## Memorandum

To	Richard Feinberg, PPG	Page	1
CC	Tom Gibbons (CB&I), Scott Mikaelian (AECOM); Site 174 – Dennis Collins Park, Bayonne, NJ		
Subject	<b>RAWP Addendum - Additional Remedial Investigation Activities to Assess Extent of Visible CCPW</b>		
From	Al LoPilato, AECOM		
Date	June 26, 2013

FIGURE 1

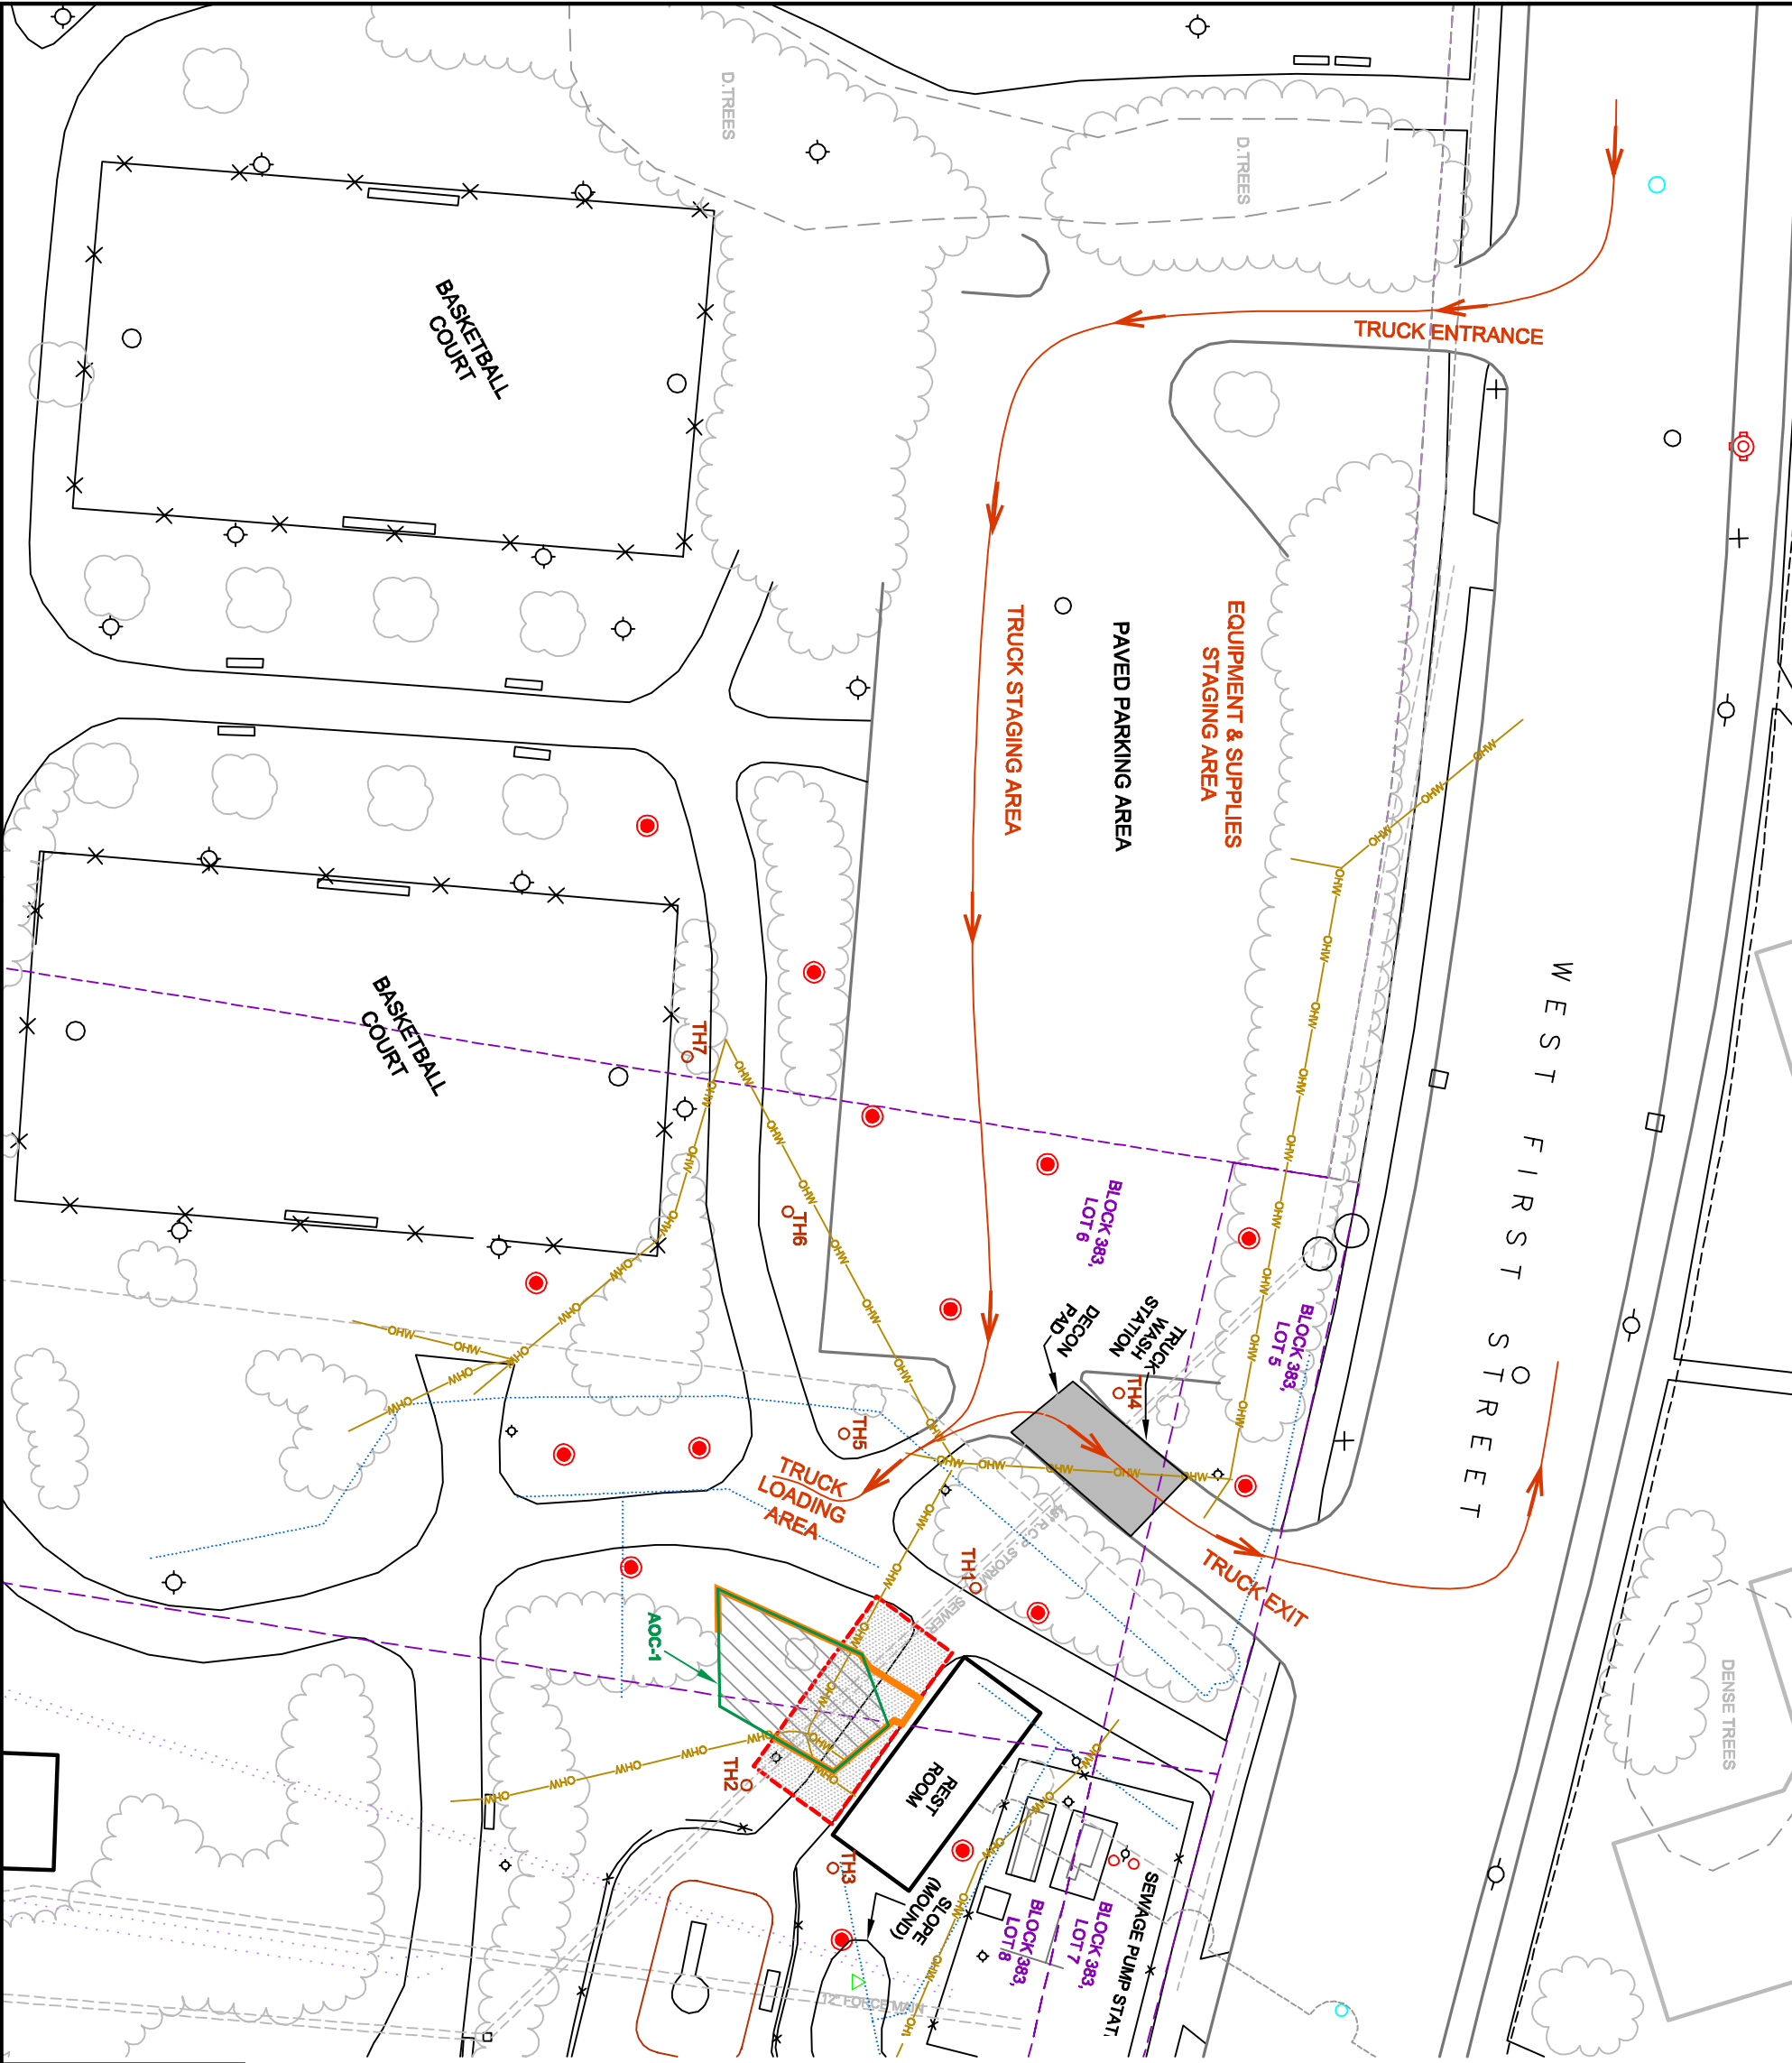
The purpose of this additional Remedial Investigation (RI) is to delineate the areal extent of visible CCPW material, which was previously encountered beyond the proposed excavation limits during the initial soil remedial action activities on April 8, 2013. As depicted on attached Figure 1, and as discussed with PPG, NJDEP and Weston on a conference call on June 3, 2013, at least 14 additional test holes will be advanced to further assess the extent of visible CCPW at Site 174. In addition, AECOM plans to manually advance via hand-auger one soil boring in the landscape berm adjacent and north of the playground area.

As discussed with NJDEP, these proposed field activities will generally be conducted pursuant to the requirements of the previously approved Remedial Action Work Plan (RAWP). The work will be implemented in discrete, small areas of investigation (exclusion zones) at each of the delineation locations proposed on Figure 1.
